Town of Mooresville
Facilities and Project Management
413 North Main Street
Mooresville NC 28115
704-555-1707

Addendum No.2

Requests for Information

DRAWING NUMBER
 SC31655

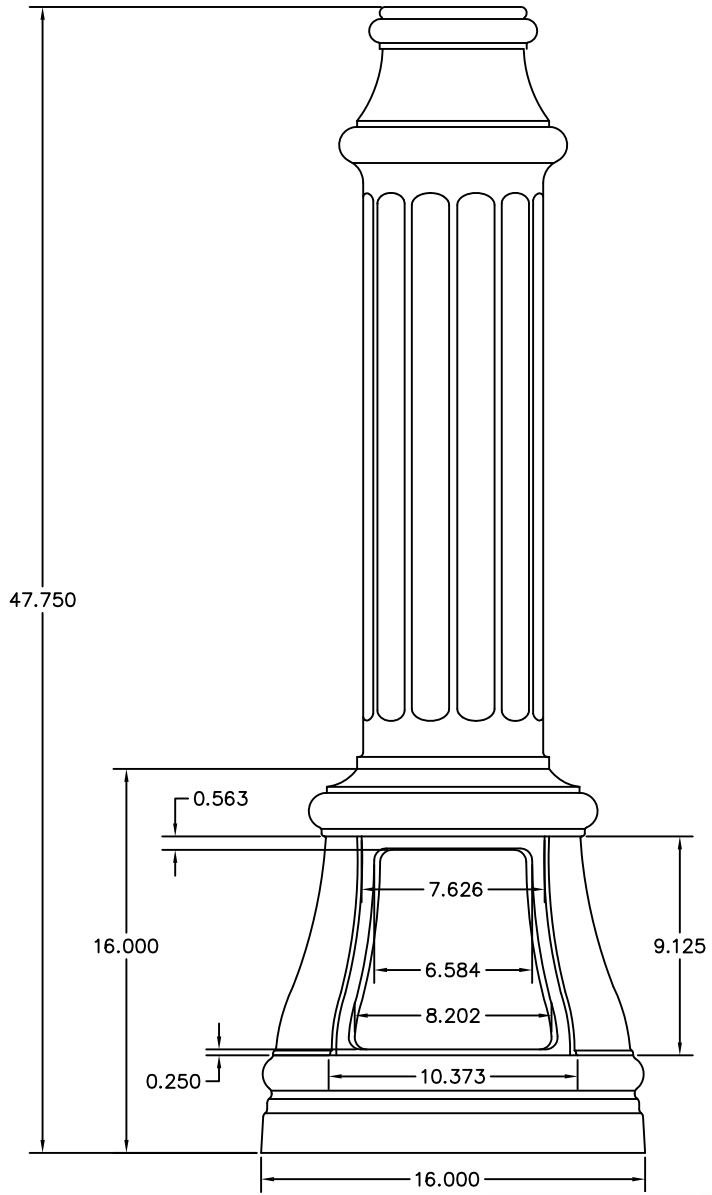
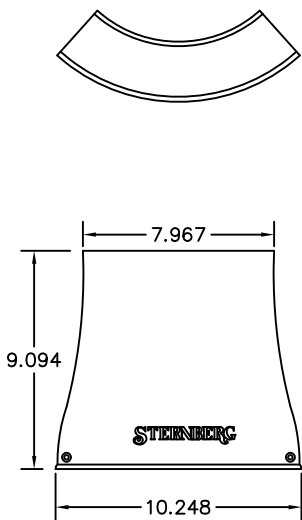
- **Answer: Please see the street paving component of Detail #5/C9.30.**
- Is there a list of owner supplied/contractor installed items in the specs?
 - **Answer: There are supplied/customer owned light poles for the site lighting located throughout. The specs for these lights are attached.**
